**SERVICE CHANGES**

**1. CHANGES ON CIRCUIT DIAGRAM:**

**Circuit diagram including new Stator unit**

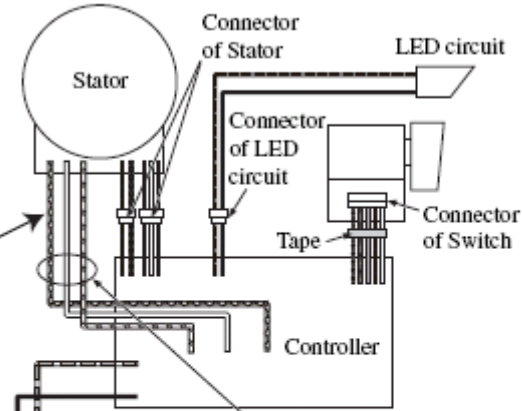
When replacing a part of the current stator by the new parts, cut the lead wires (3pcs.) between Stator and Controller and then connect the new Controller set or the new Stator set with insulated connectors.
